Ref: 230-004-004L

**6 Endeavour Road, Port Douglas
Operational Works Application OP 2023_5480/1
Response to Information Request**

We refer to Council's information request for the above application dated 17 August 2023 (copy attached) and respond as detailed below.

ENDEAVOUR STREET SUBDIVISION	
EARTHWORK & SITE LEVELS	
DRAWING NO.	230-004-C04
REVISION	B

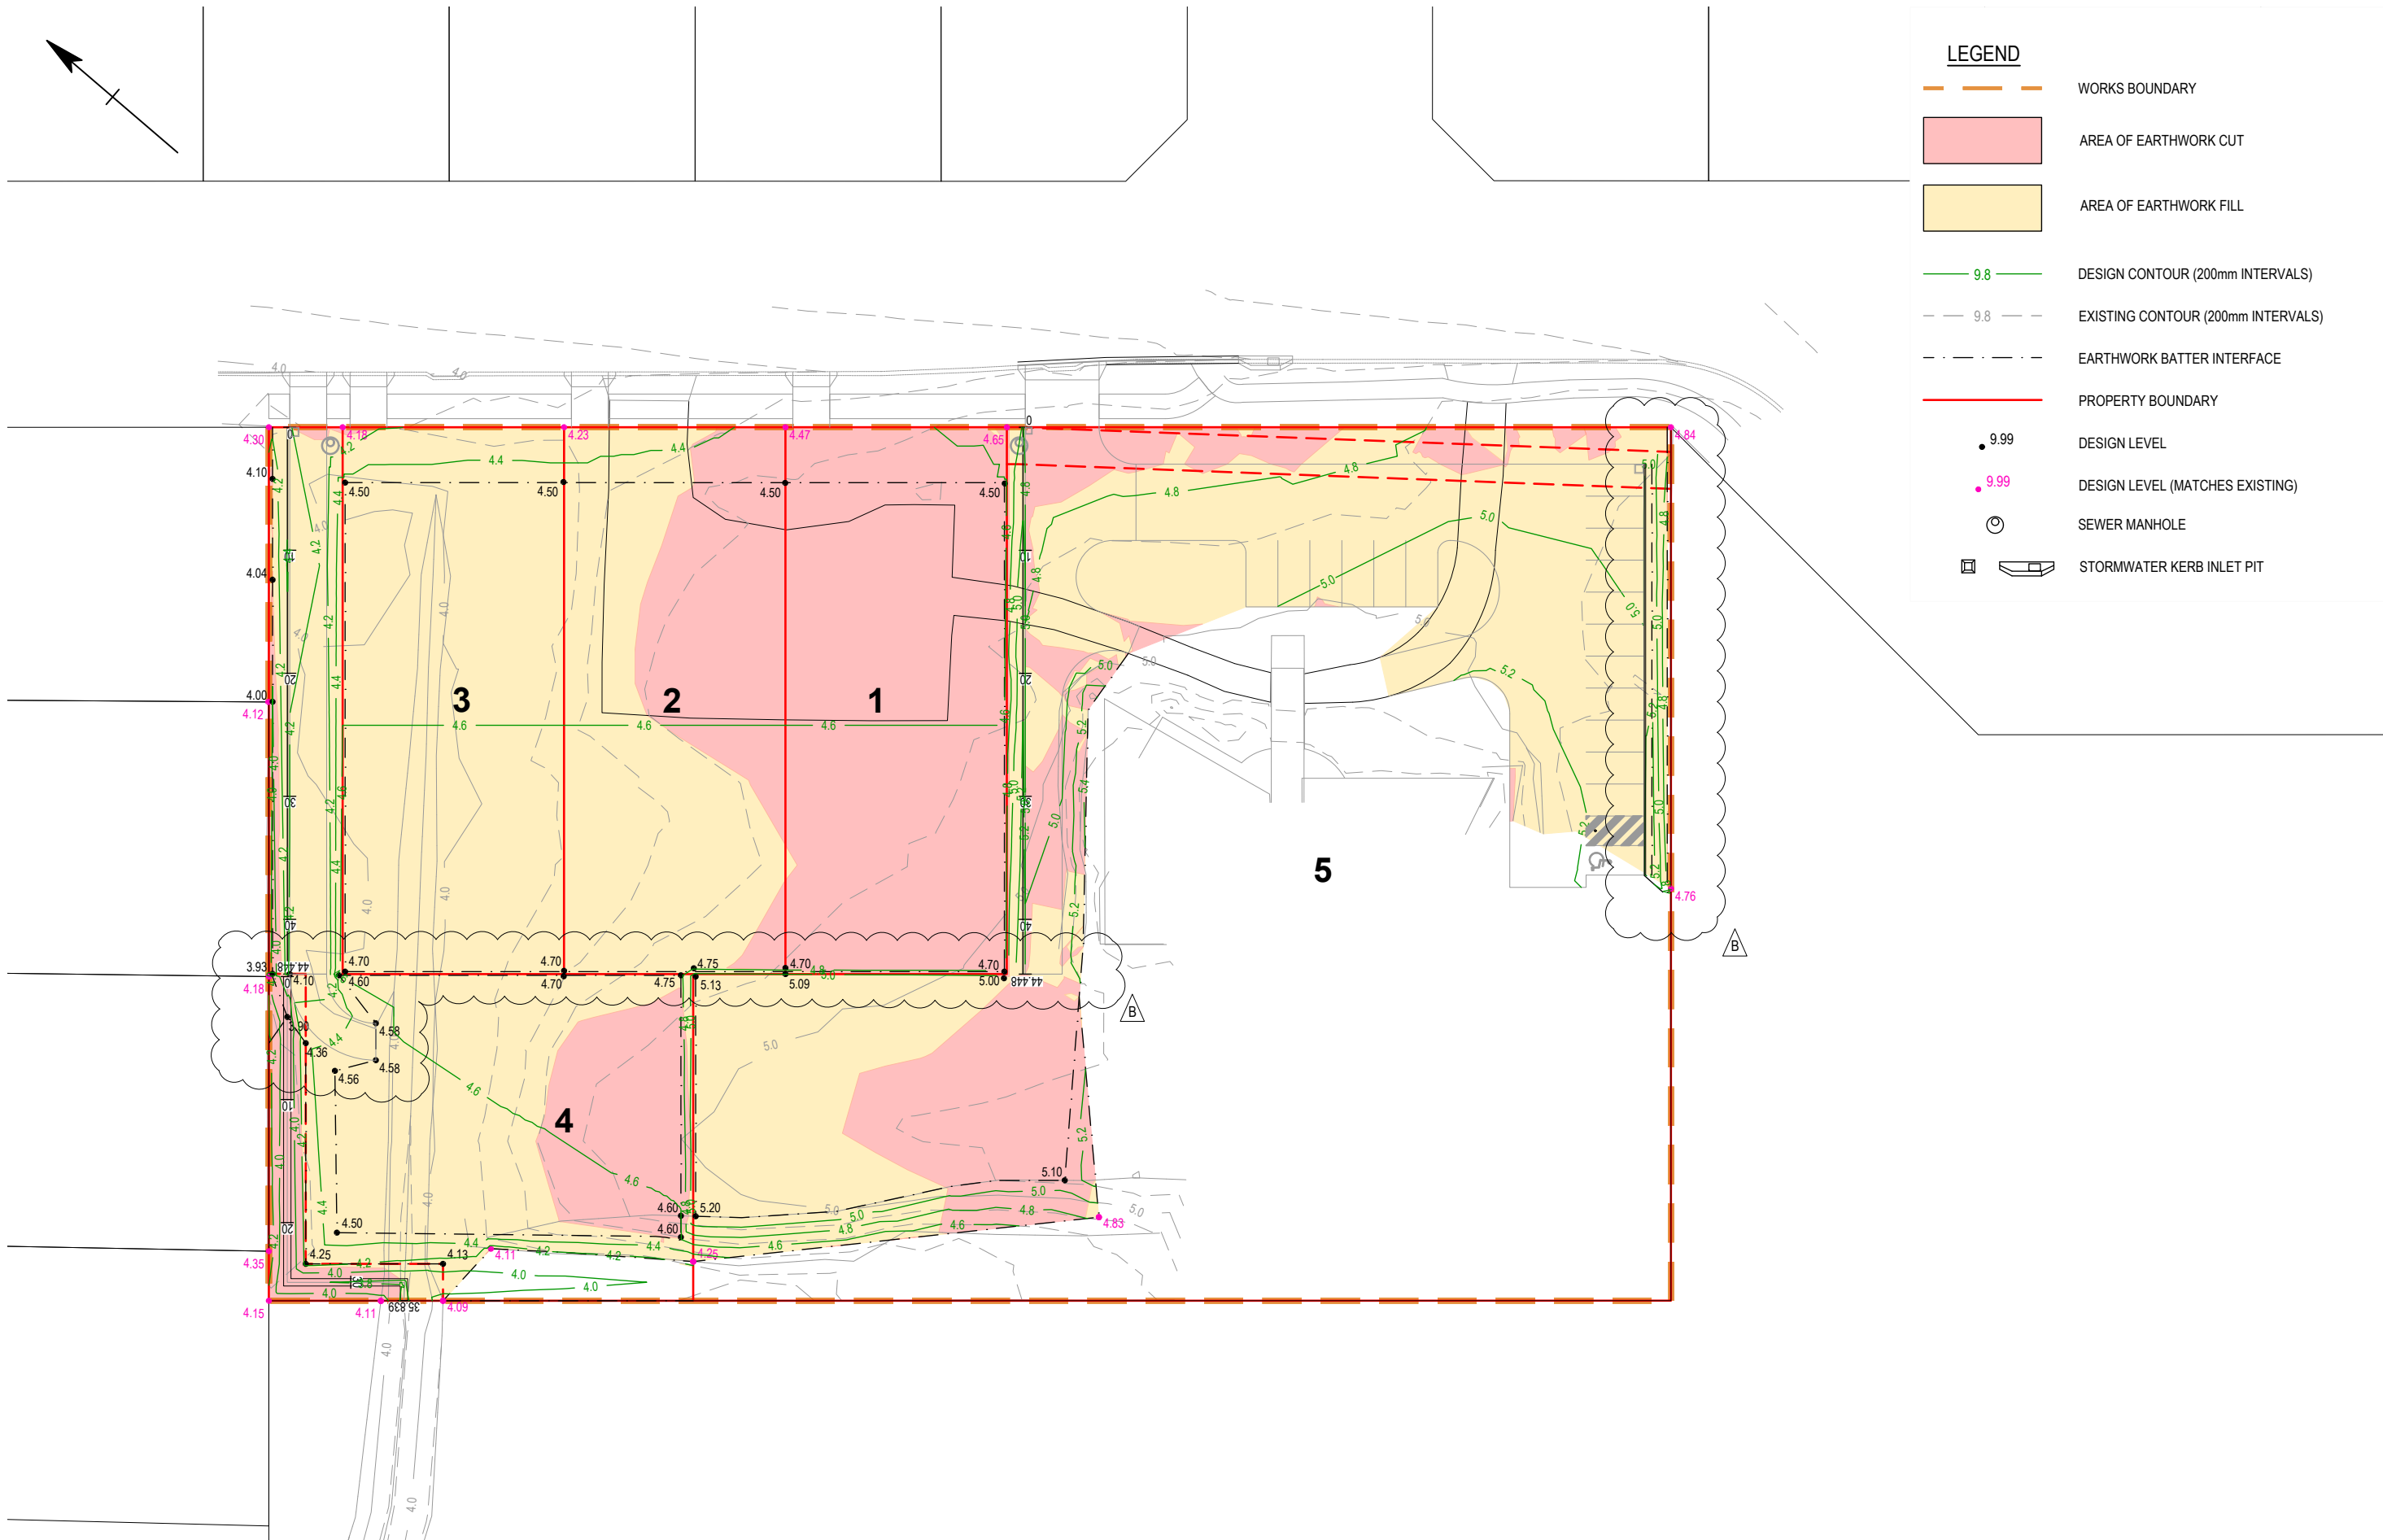
Item 4 - Earthworks

Item 5 - Earthworks

We have provided adjusted level information on the drawing to clarify the design intent.

We have provided additional level information at this lot interface to clarify the design intent.

ENDEAVOUR STREET SUBDIVISION	
STORMWATER DRAINAGE LAYOUT	
DRAWING NO.	230-004-C07
REVISION	B

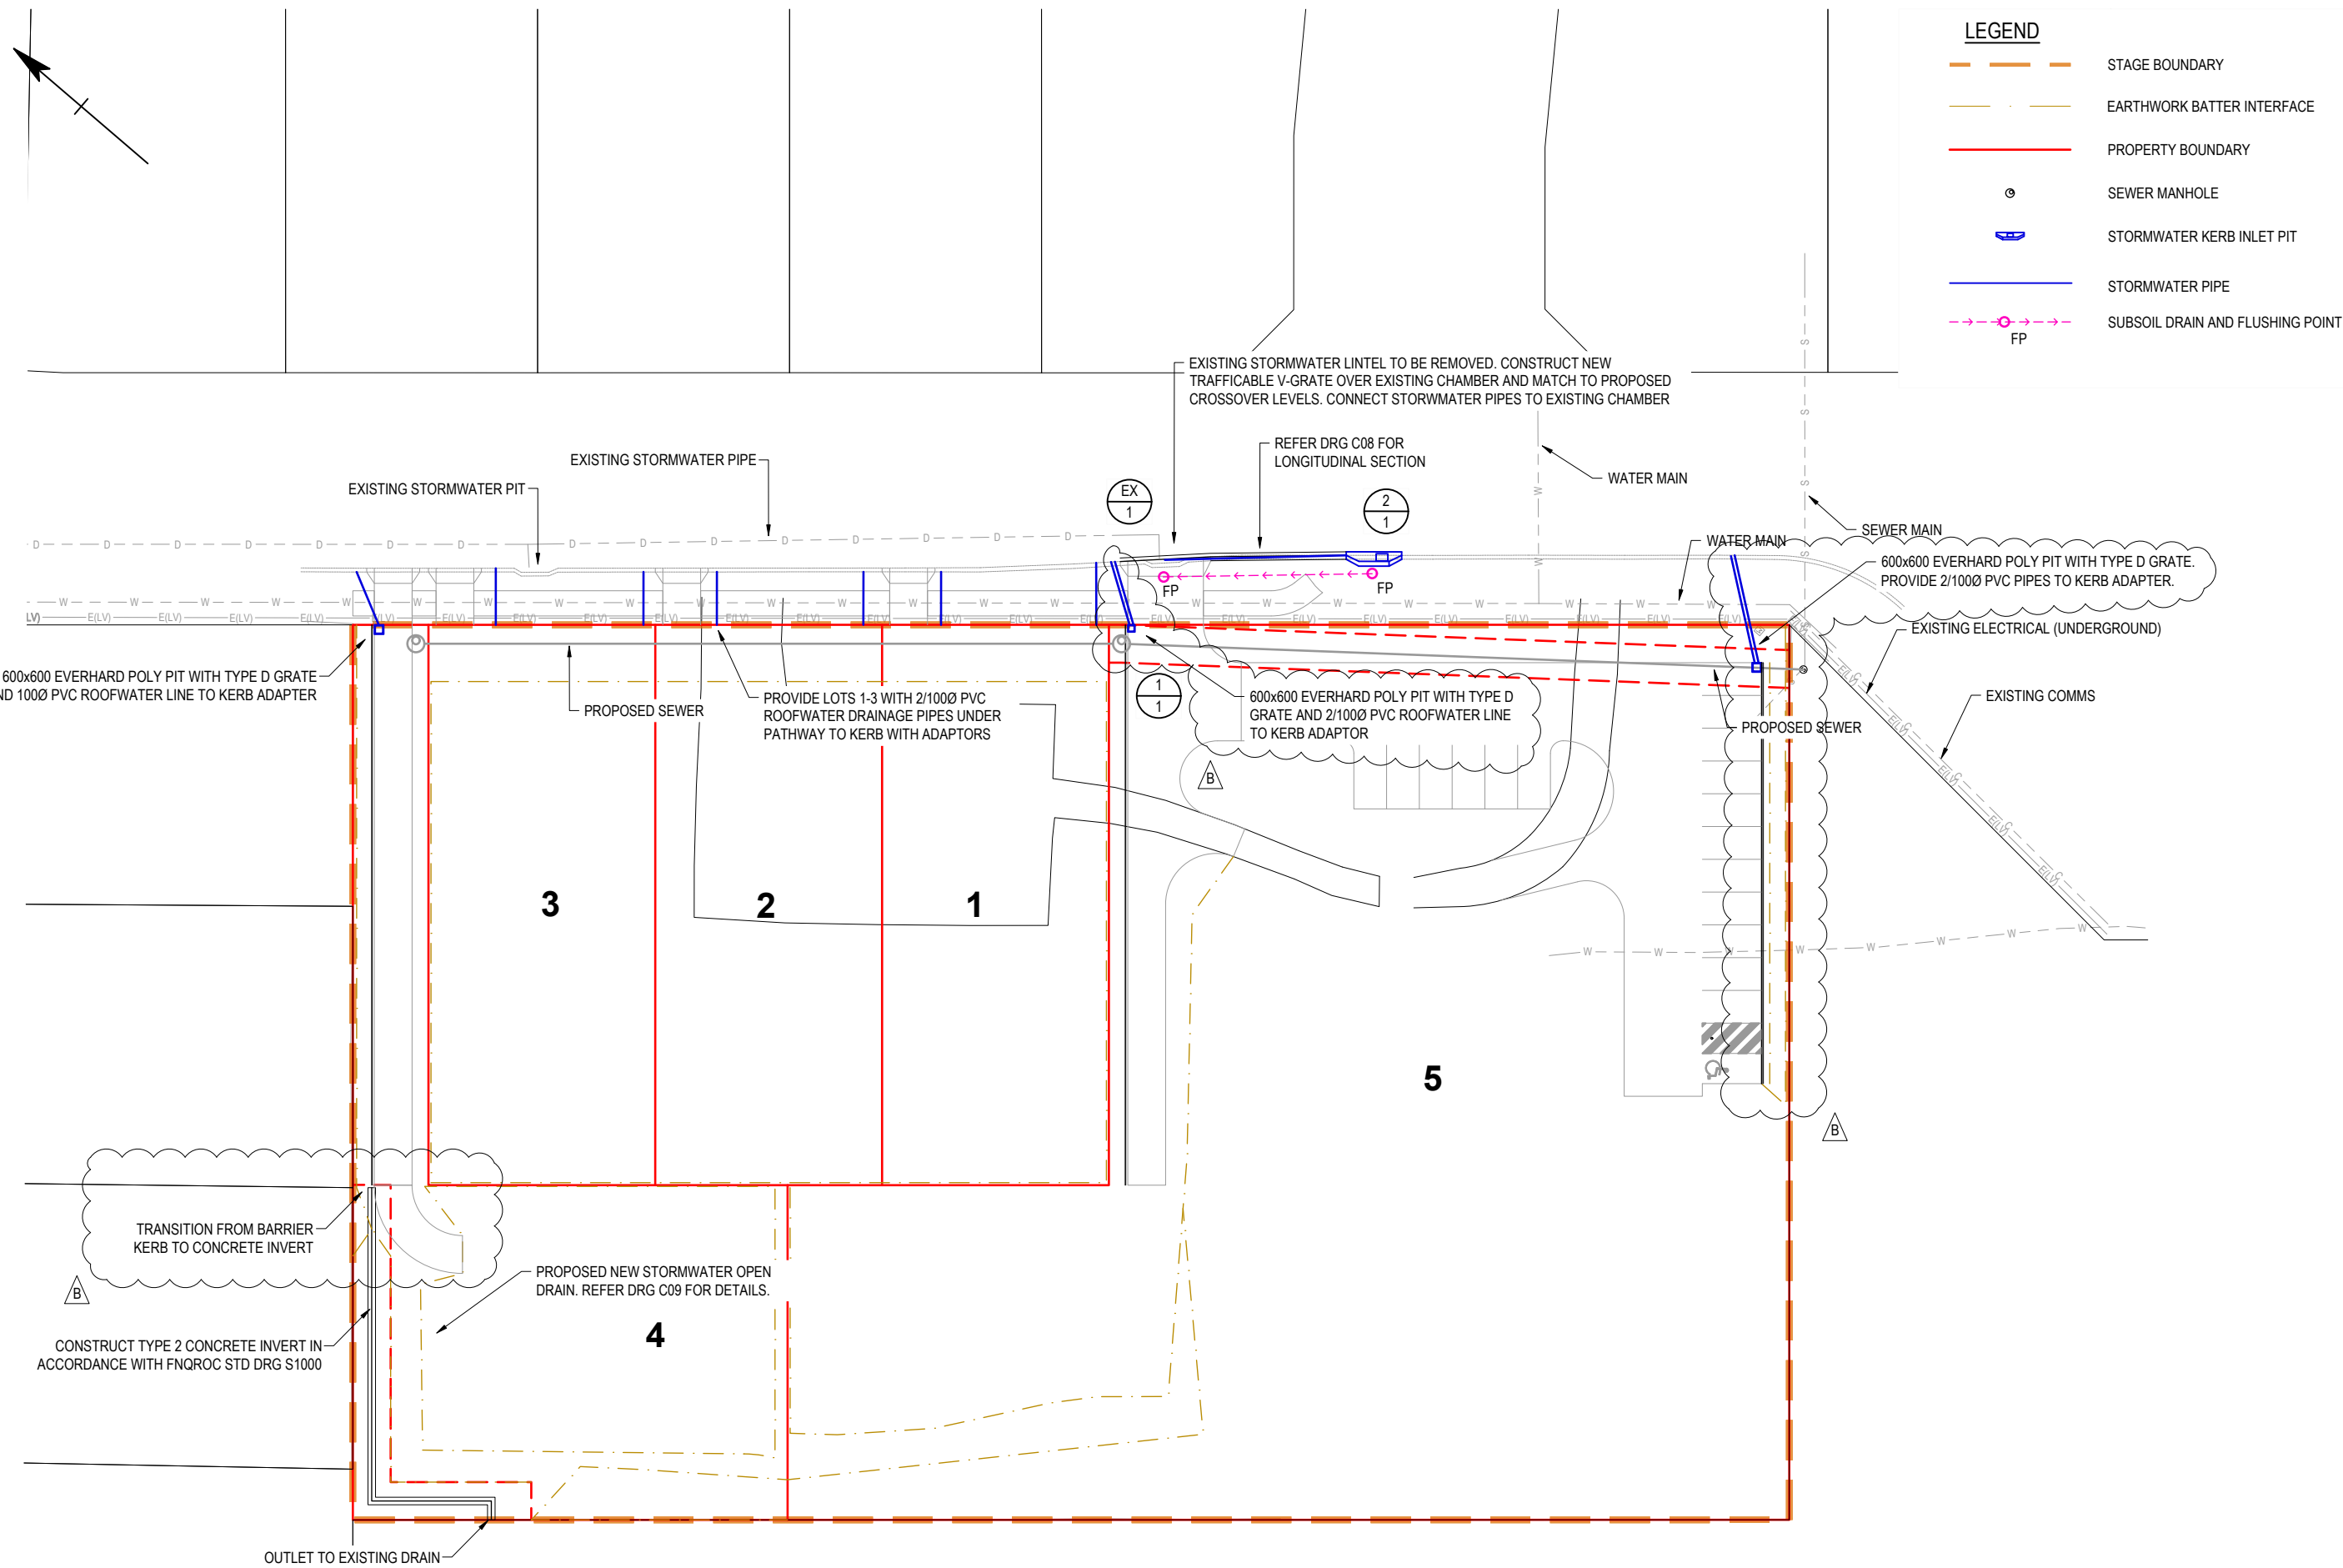
Item 2 - Stormwater

Item 3 - Stormwater

We assume that Council refers to the 600mm x 600mm field inlet pit located within Lot 5. This has been amended to a 450mm x 450mm Everhard poly pit, which provides 424mm clearance from the outside wall of that pit to the outside wall of the sewer manhole. This meets the clearance requirements in accordance with FNQROC, QUDM and CTM.

This portion of Lot 5 currently drains westward toward the school property with sheet flow crossing the boundary. The development does not propose to change this arrangement however, it does reduce the drainage catchment contributing to that boundary, thereby reducing discharge to the school. We therefore consider that an appropriate drainage arrangement is provided according with Section 3.9.1 of QUDM.

ENDEAVOUR STREET SUBDIVISION		
STORMWATER DRAINAGE		
OPEN DRAIN DETAILS		
DRAWING NO.	230-004-C09	REVISION B

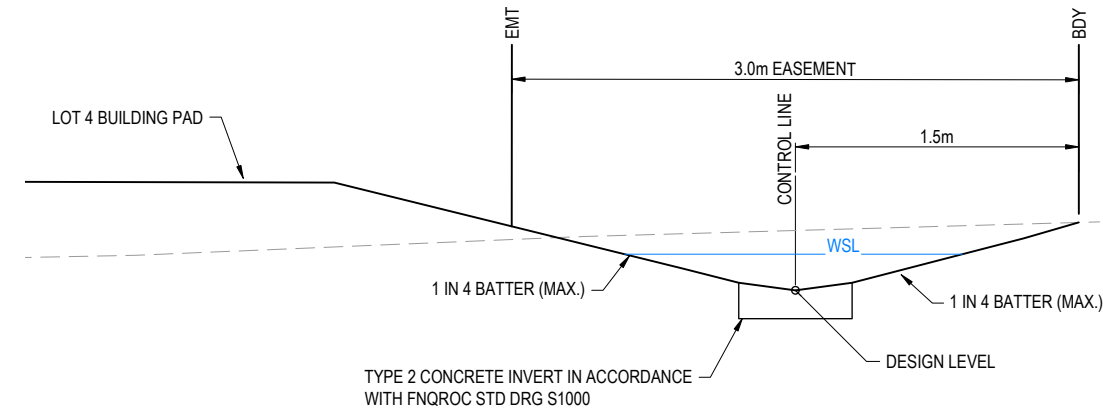
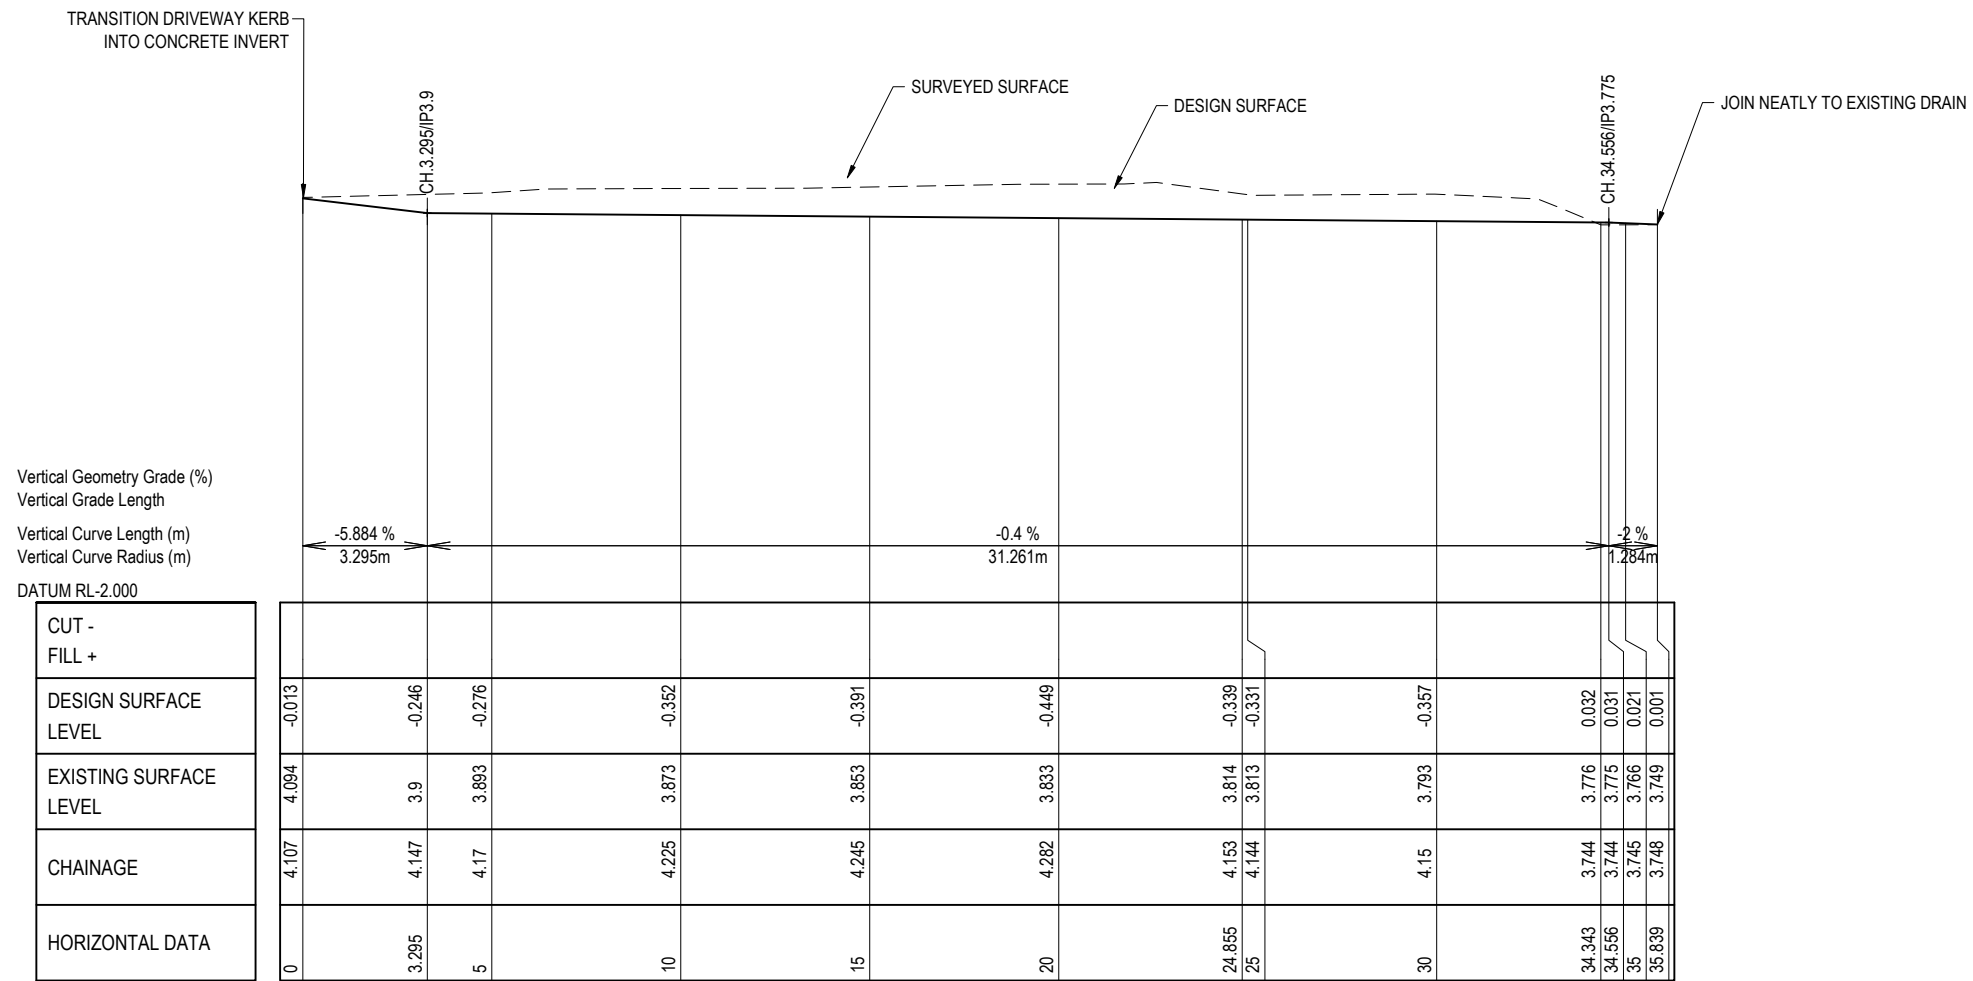
Item 1 - Stormwater

Existing LIDAR data for the area indicates that the existing Hope Street lots generally fall to the front. On re-inspection, it could be interpreted that there may be a small portion of those lots that does fall to the rear. We have therefore adjusted the design in this area to introduce a drainage path along the driveway to receive run-off and divert to the west.
